Match ellis project name:
CLE/WAR SR 48 6.65 Sidewalk

CLE/WAR SR48 6.65 & BUTTERWORTH SIDEWALK

STAGE 1 SUBMITTAL - AUGUST 29, 2025

TITLE SHEET

PLAN AND PROFILE - STATE ROUTE 48
STA. 106+00 TO STA. 111+00

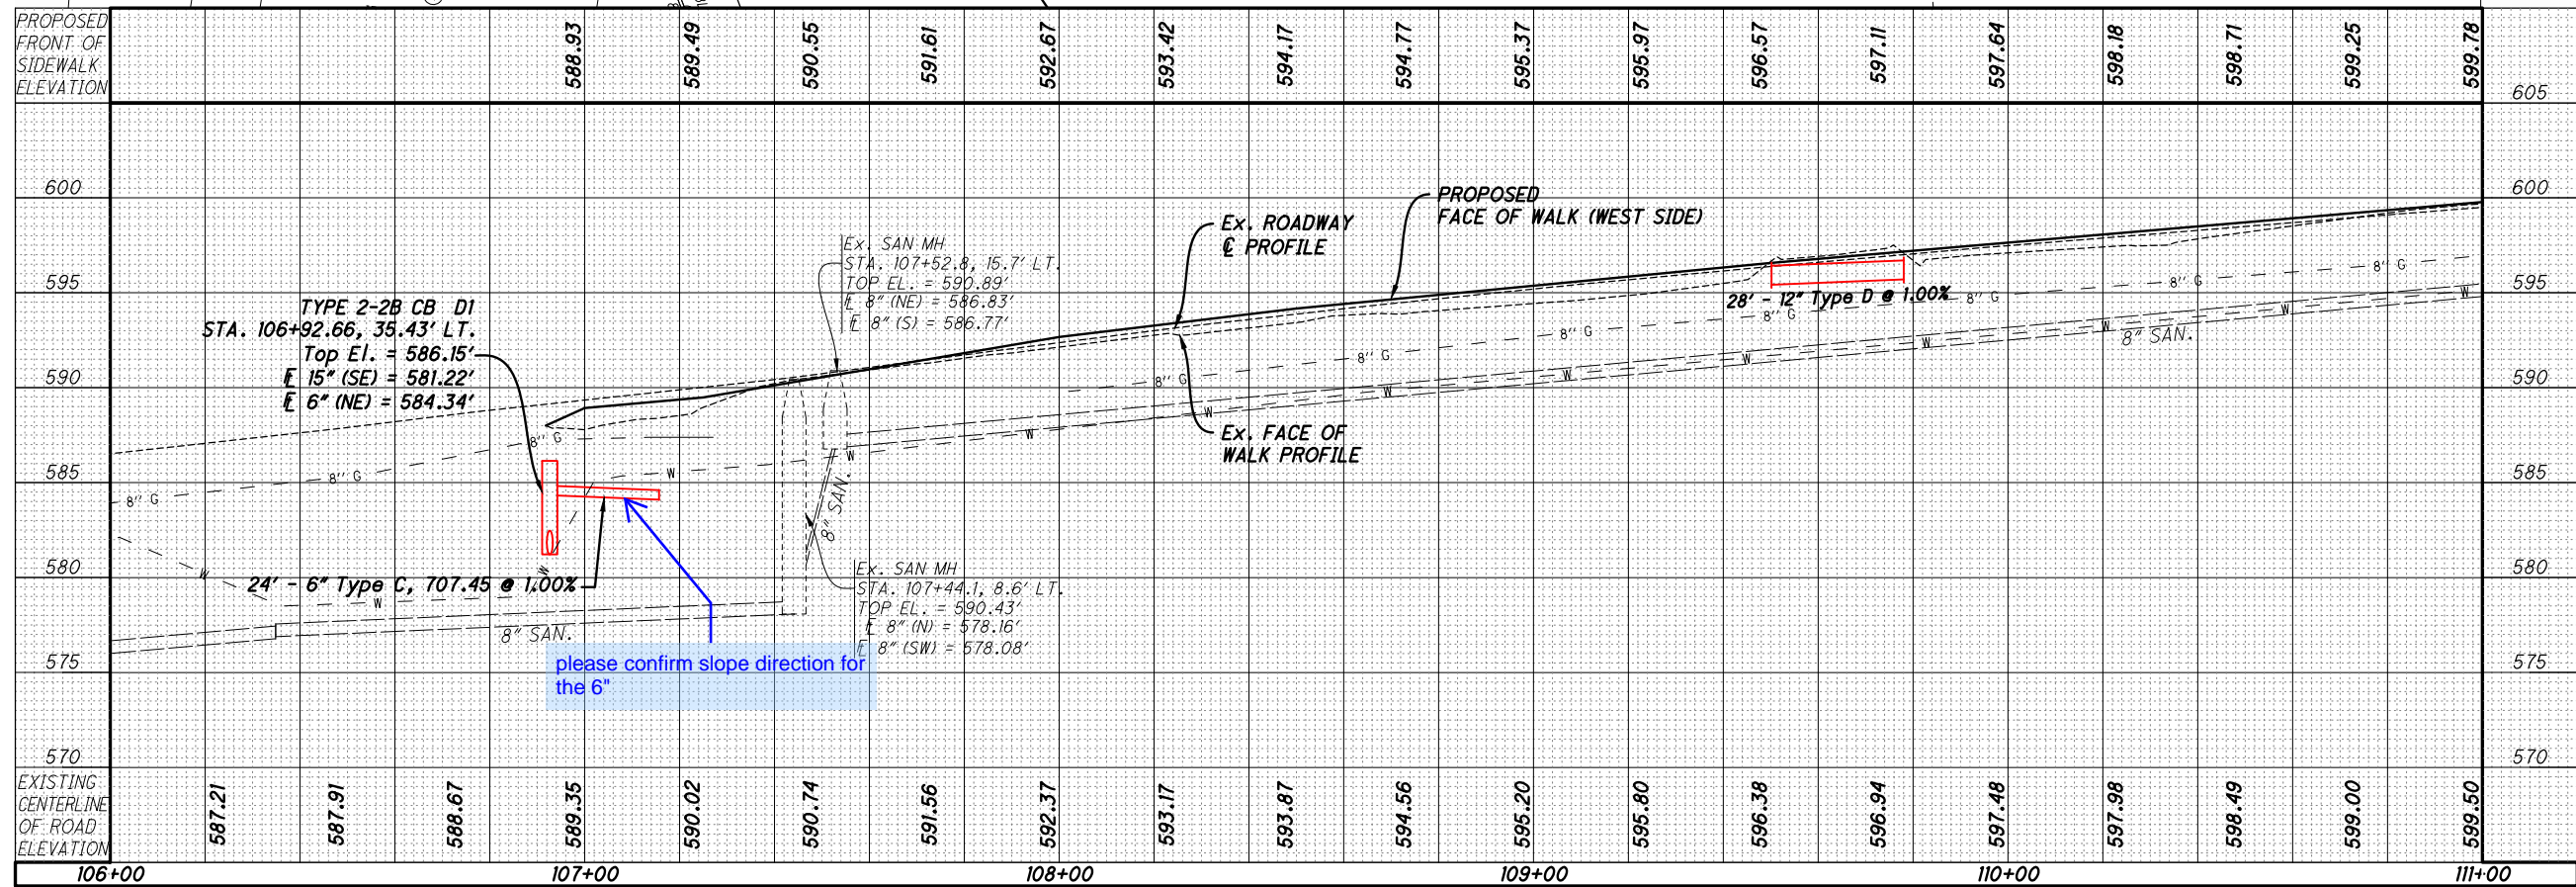
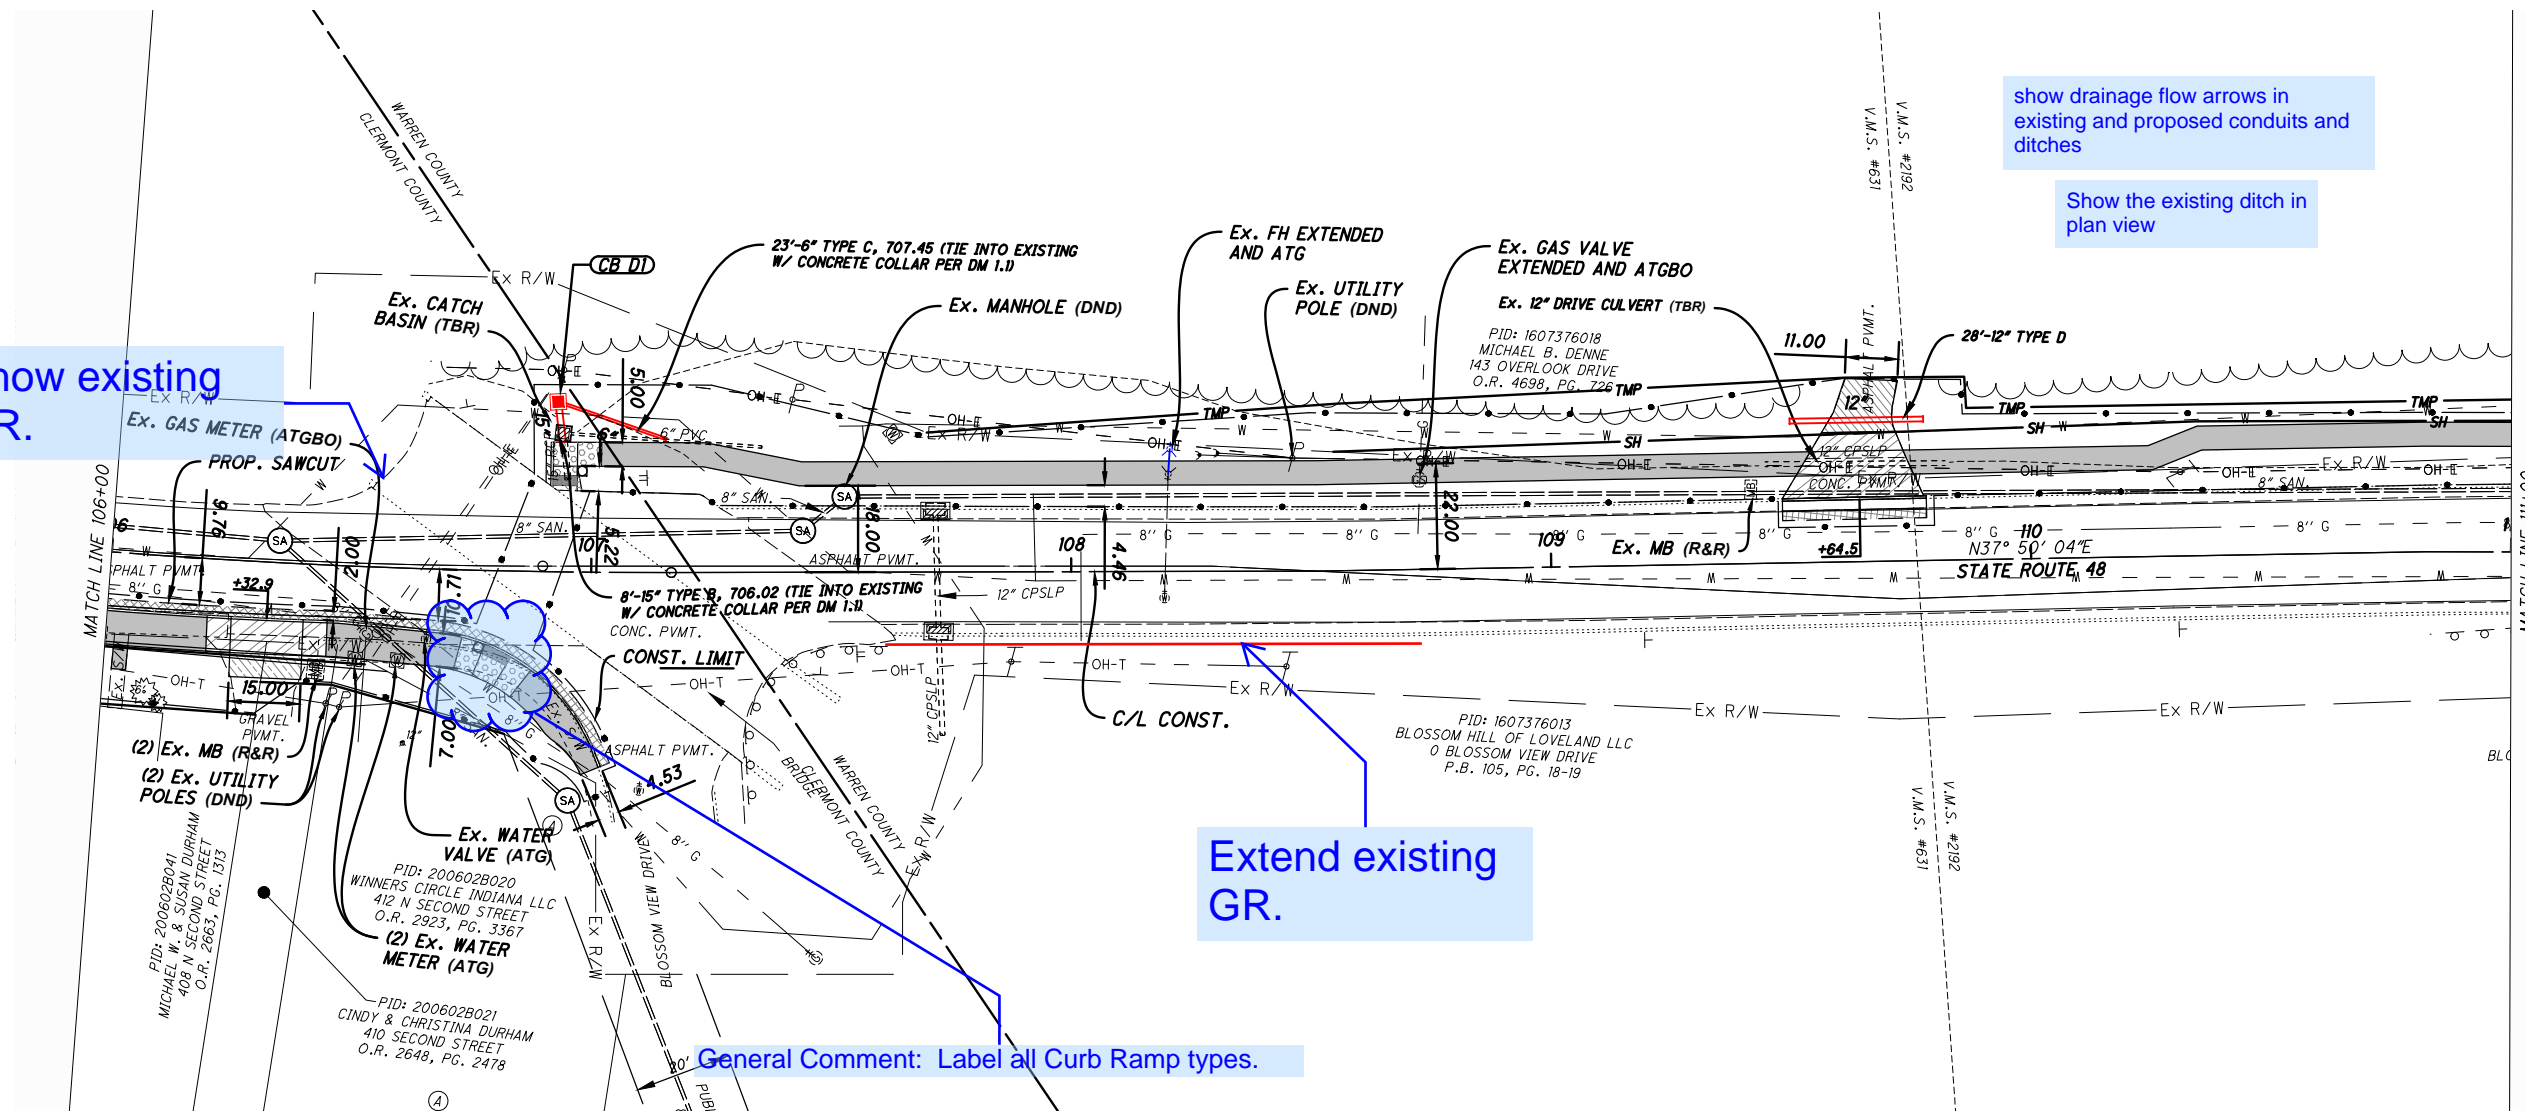
Show existing GR.

show drainage flow arrows in existing and proposed conduits and ditches

Show the existing ditch in plan view

General Comment: Label all Curb Ramp types.

PLAN AND PROFILE - STATE ROUTE 48
STA. 111+00 TO STA. 116+00

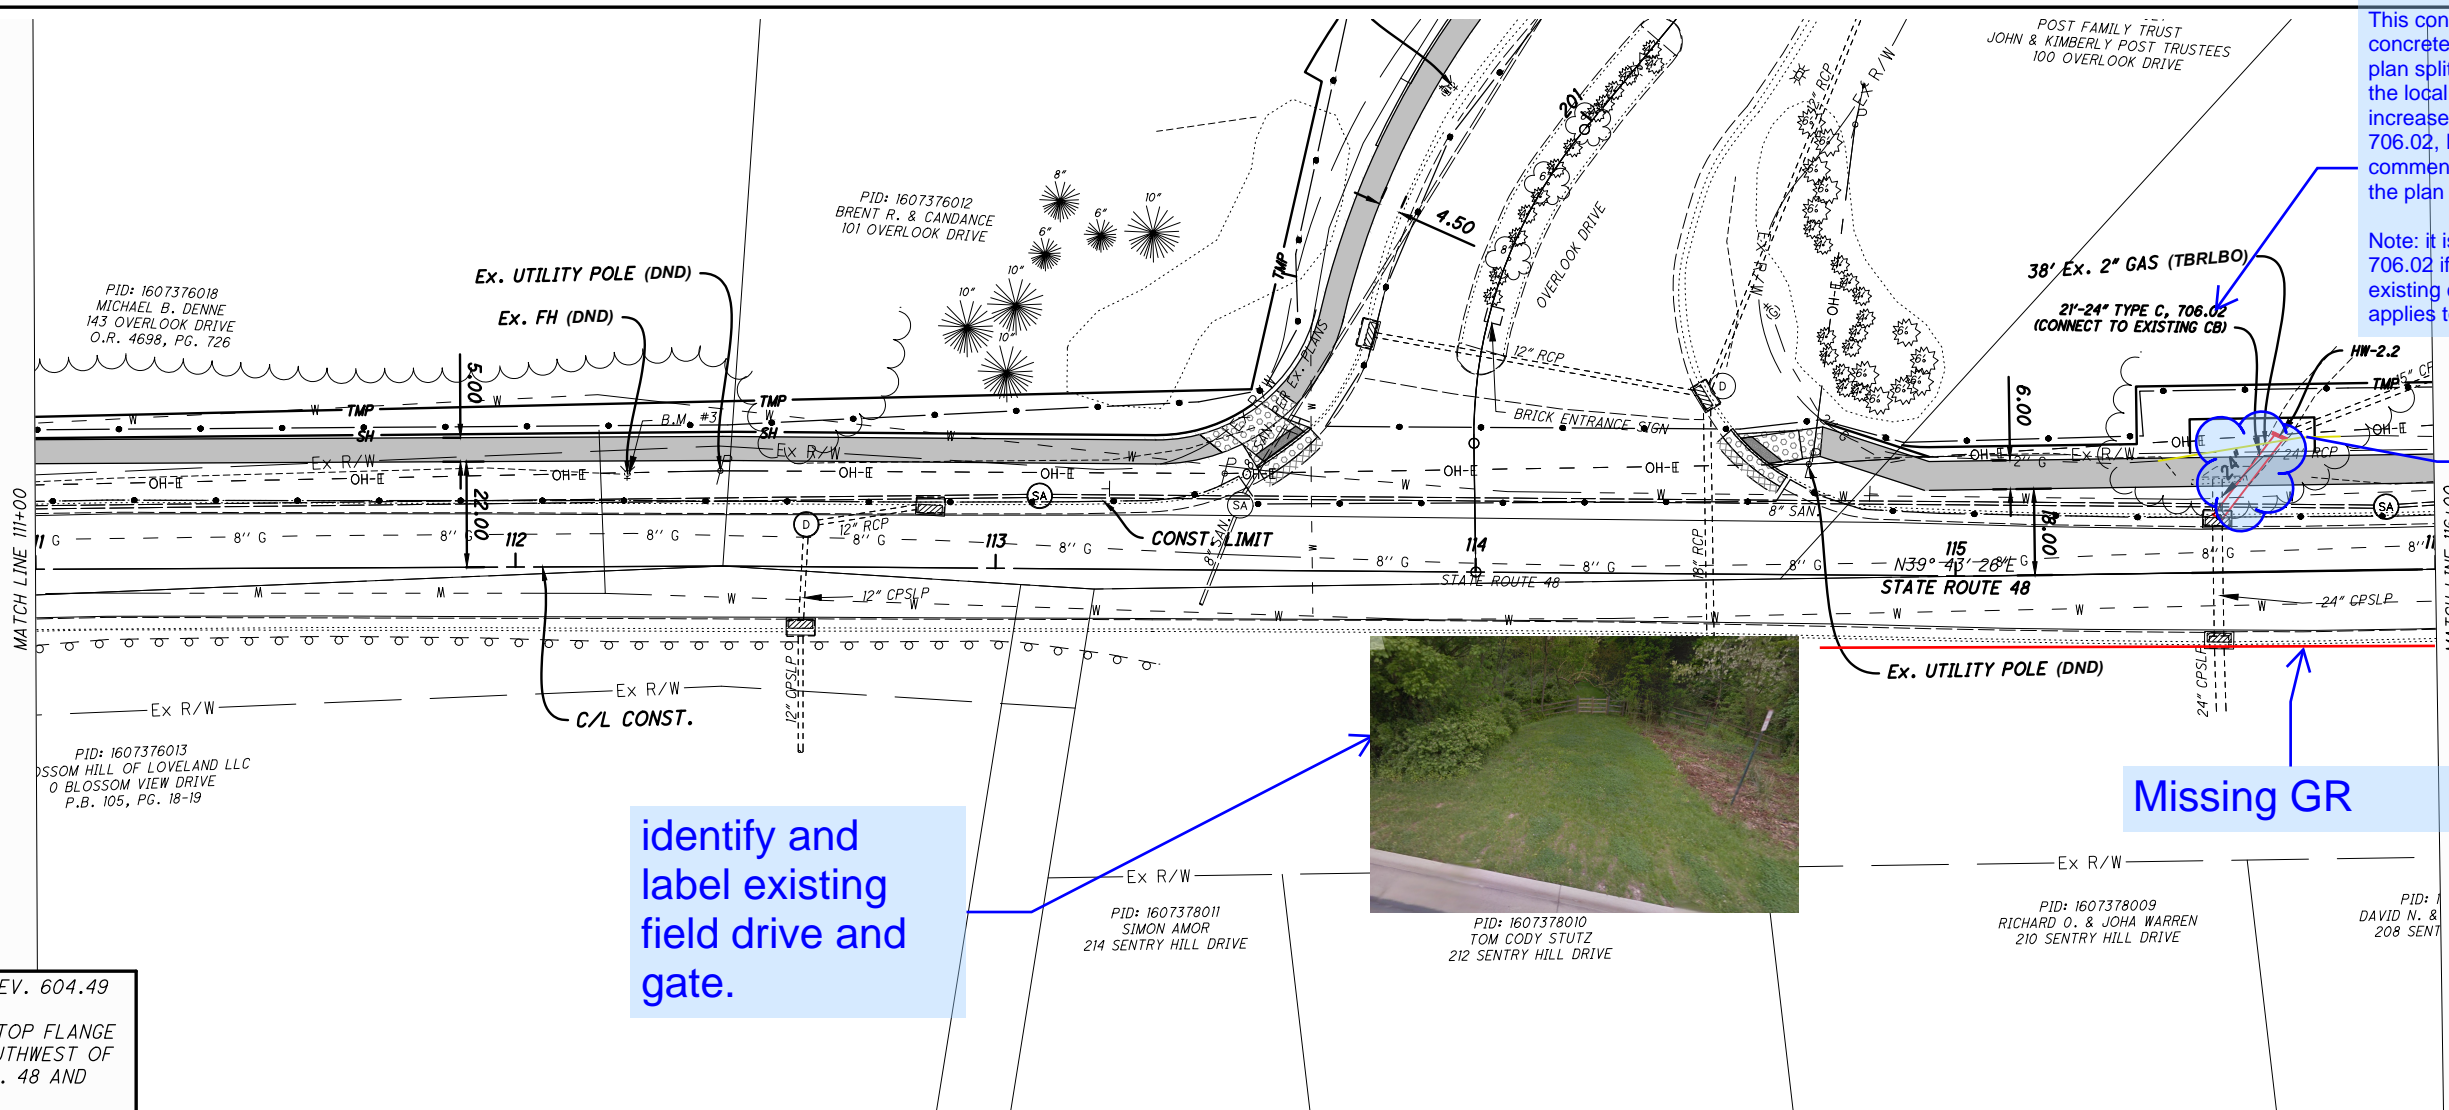
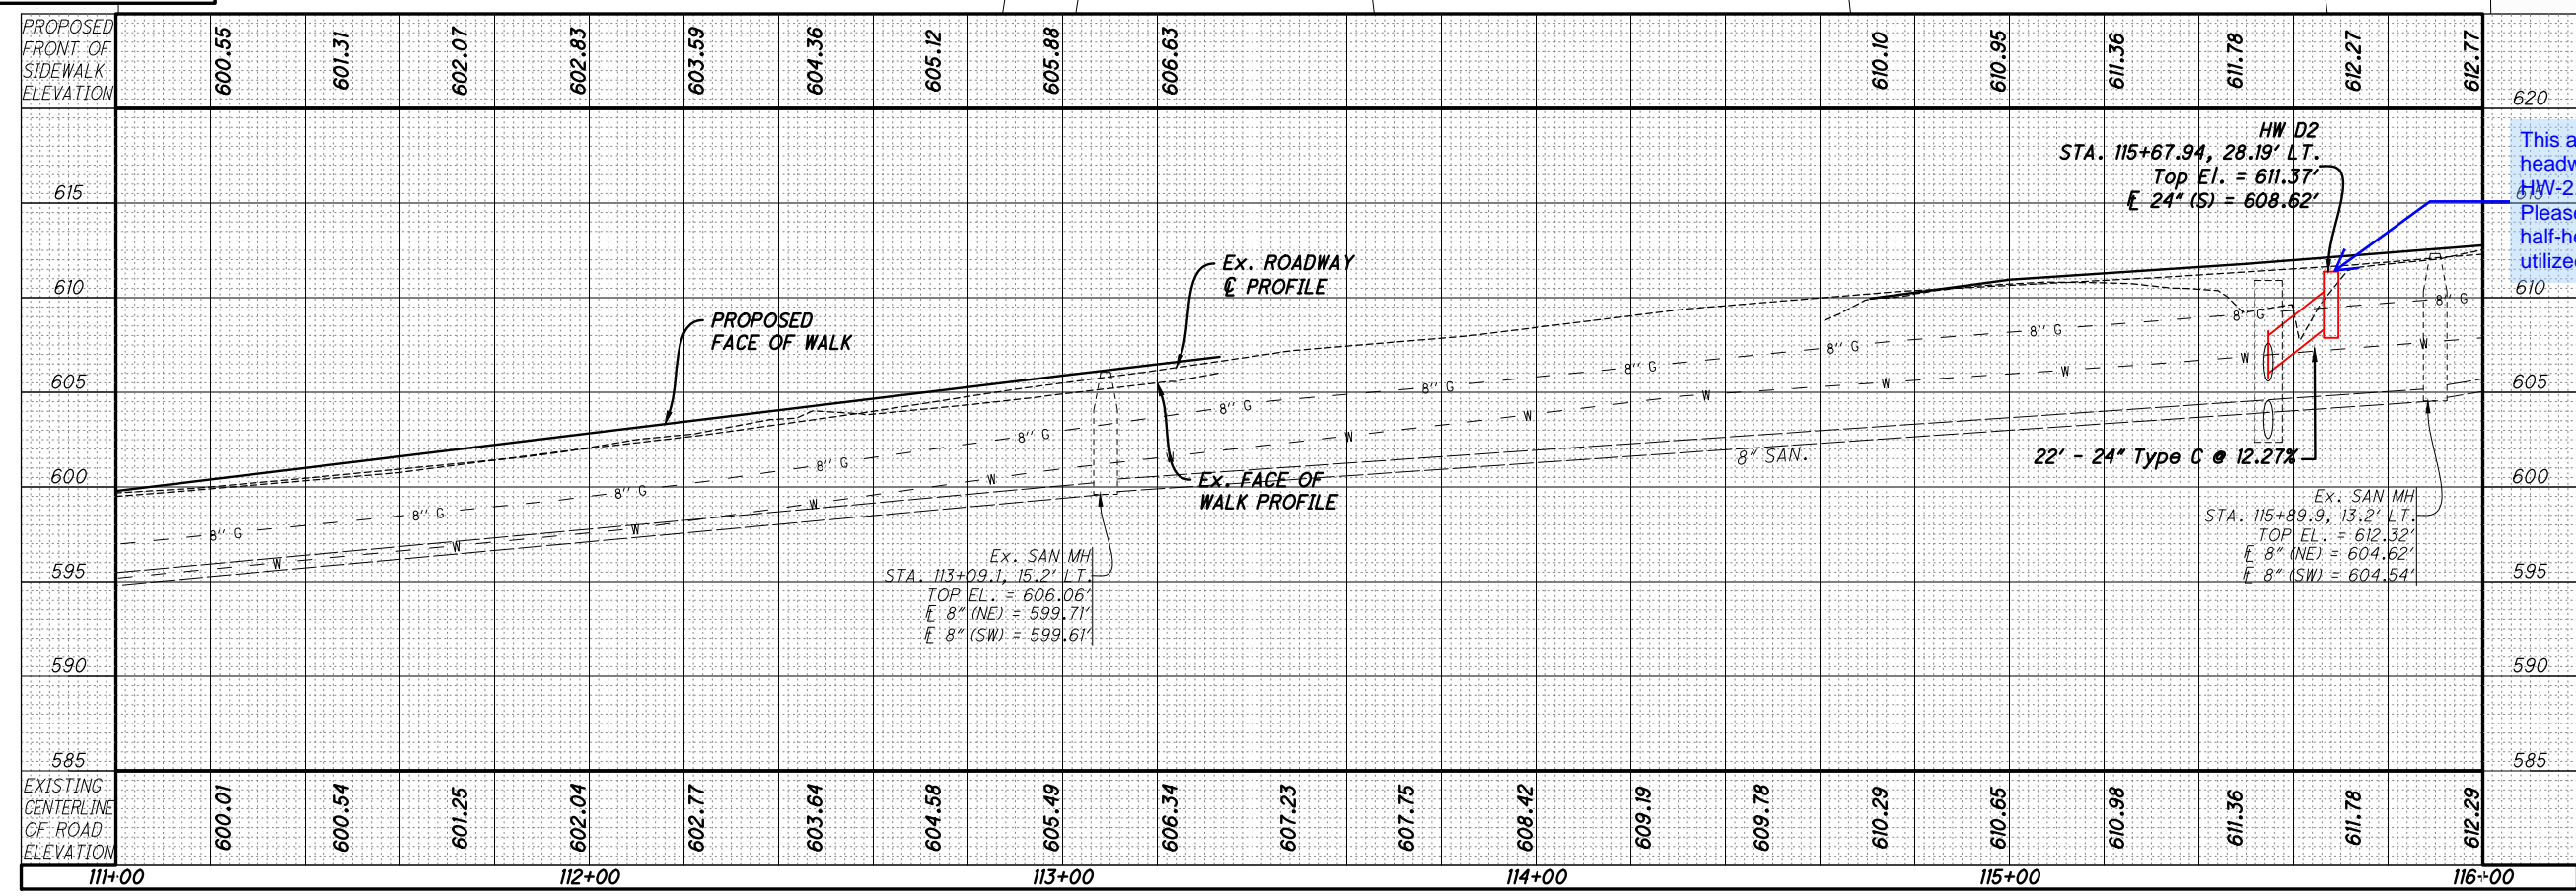
This conduit doesn't need to be concrete. If concrete is desired, plan splits will be required and the local will need to pay for the increase in cost. If you leave as 706.02, I will make additional comments at stage 3 to clarify the plan requirements if needed.

Confirm if waterline and gas line are in conflict with proposed pipe. If they are in conflict, will additional r/w be required?

Missing GR

identify and label existing field drive and gate.

This appears to be a full height headwall, but the label is for HW-2.2 which is half-height. Please confirm. Normally, a half-height headwall would be utilized
